# Access Compliance Report

## Public Rights-of-Way

### (Curb Ramps)

Intersection ID: 13514	Main Street: WINGATE_AV	Cross Street: OCRACOKE_ST	Location: S
ADA ID: F63215A40A1B	Ramp Type: Perp	Initial Pass/Fail: Fail	Overall Compliance: No
Severity Score: 21.25			
Codes/Mitigation Info/Possible Solution		Field Measurements/Component Compliance

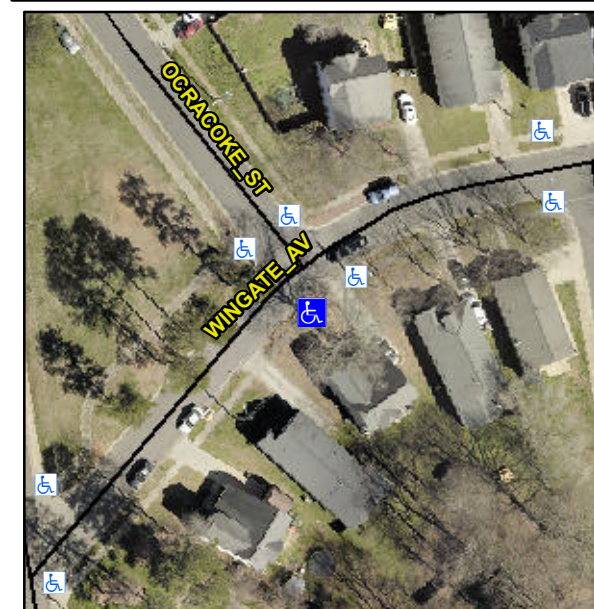
**Remove & Replace Entire Ramp.**

**R304.5.1, R304.2.2**

Compliance	Description	Data	Compliance	Description	Data
N/A	Ramp Length (in)	59.0	No	Ramp Slope (%)	9.2
No	Ramp Width (in)	47.0	Yes	Ramp XSlope (%)	1.0
N/A	Flare Type LT	N/A	N/A	Flare Type RT	N/A
N/A	Flare Slope LT (%)	N/A	N/A	Flare Slope RT (%)	N/A
N/A	Flare Traversable LT?	N/A	N/A	Flare Traversable RT?	N/A
N/A	Landing Length (in)	N/A	N/A	DWS Provided?	N/A
N/A	Landing Width (in)	N/A	N/A	DWS Contrast?	N/A
N/A	Landing Slope (%)	N/A	N/A	DWS Length (in)	N/A
N/A	Landing X Slope (%)	N/A	N/A	DWS Full Width?	N/A
N/A	Landing Curb? (Y/N)	N/A	N/A	DWS Offset (in)	N/A
N/A	Shared Landing?	N/A			
N/A	Gutter Ponding?	N/A	N/A	Gutter Slope (%)	N/A
N/A	Gutter Lip Ht (in)	N/A	N/A	Gutter X Slope (%)	N/A
N/A	Painted X Walk1?	No	N/A	Painted X Walk2?	N/A
	X Walk 1 Direction	To N		X Walk 2 Direction	N/A
N/A	X Walk 1 Width (in)	N/A	N/A	X Walk 2 Width (in)	N/A
	X Walk 1 Slope (%)	8.5		X Walk 2 Slope (%)	N/A
	X Walk 1 X Slope (%)	1.6		X Walk 2 X Slope (%)	N/A
